Re: St. Lucie Unit 1
Docket No. 50-335
In Service Inspection Plan
Third Ten-Year Interval
Relief Request 22

**St. Lucie Unit 1 Relief Request 22
External Weld Between Small Bore Nozzle and
Reactor Coolant Piping Hot Leg**

Small bore alloy 600 nozzles welded to the reactor coolant system (RCS) piping hot legs
Reactor Coolant Piping Nozzle Details
FPL Drawing Numbers: 8770-366, 8770-1496, 8770-3344

FIGURE 1
FLOW NOZZLE ORIGINAL WELD JOINT

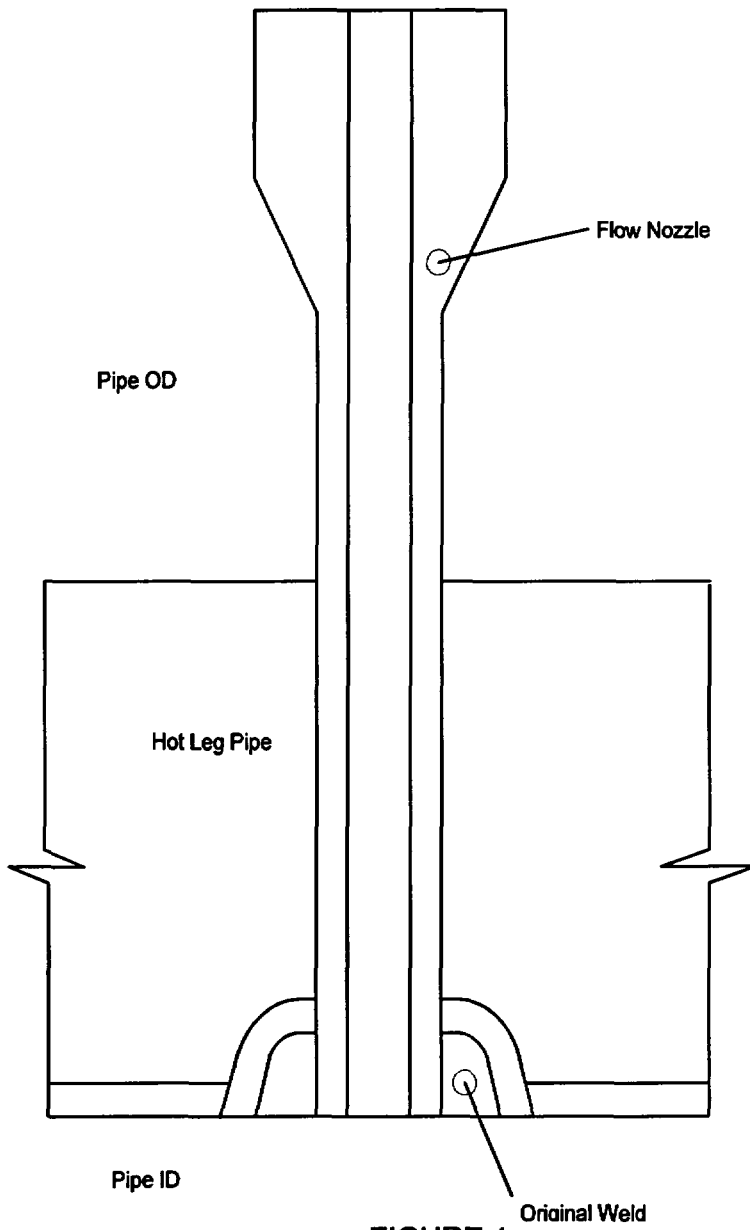
There are two types of small-bore nozzles of concern: flow measurement nozzles and nozzles that hold resistance temperature detectors (RTD). The weld configuration for the flow nozzle is shown in Figure 1 and the weld configuration for the RTD nozzle is shown in Figure 2.

The original small-bore nozzle to hot leg piping weld configuration is extremely difficult to UT from the outside diameter of the hot leg pipe. This is due to the compound curvature and distance from the outside surface to the weld, as can be seen in Figures 1 and 2. These conditions preclude ultrasonic coupling and control of the sound beam in order to perform flaw sizing with reasonable confidence in the measured flaw dimension. Therefore, it is impractical, and

FIGURE 3
FLOW NOZZLE NEW EXTERNAL WELD

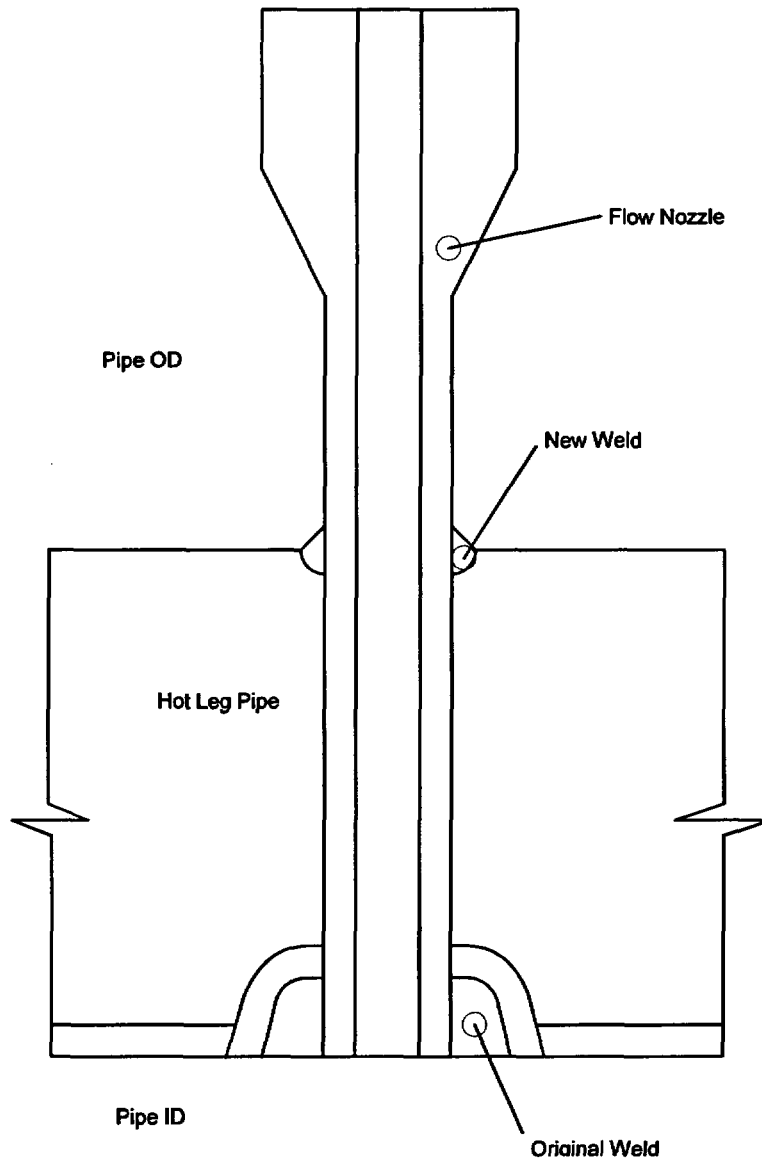
During the upcoming St. Lucie Unit 1 outage (SL1-19), FPL will be examining the RCS hot leg flow measurement and RTD nozzles for evidence of leakage. Nozzles that show evidence of leakage will be repaired. The proposed repair will be a partial penetration weld with fillet reinforcement applied to the external surface of the hot leg piping at the junction with the nozzle. The weld joint design will comply with the ASME Boiler & Pressure Vessel Code, Section III, Subsection NB, 1989 Edition, No Addenda, Figure NB-4244(d)-1, design (e), except for dimension " λ ", the gap at the internal end of the nozzle. Dimension " λ " should be 1/16 inch minimum. The repair weld will not produce a gap between the new external weld and the internal end of the nozzle; therefore " λ " will be 0 inches. The repair configuration for the flow nozzle is shown in Figure 3 and the repair configuration for the RTD nozzle is shown in Figure 4.

The repair will be a partial penetration weld with fillet reinforcement applied to the external surface of the hot leg piping at the junction with the nozzle. The welding will be done manually using the GTAW process, F-43 filler metal, preheat of 200 degrees F and no post weld heat treatment. The welding procedure specification has been qualified in accordance with ASME Boiler & Pressure Vessel Code, Section IX.

As defined by Reference 2, NB-3352.4(d), "λ" is to be 1/16 inch minimum. The proposed repair will not establish such a gap and "λ" will be zero. The new weld configuration, a nozzle penetrating a pipe with attachment welds at both the inside and outside diameters of the pipe, will require analysis in accordance with Reference 2. An appropriate analysis has been performed, References 3 and 4,
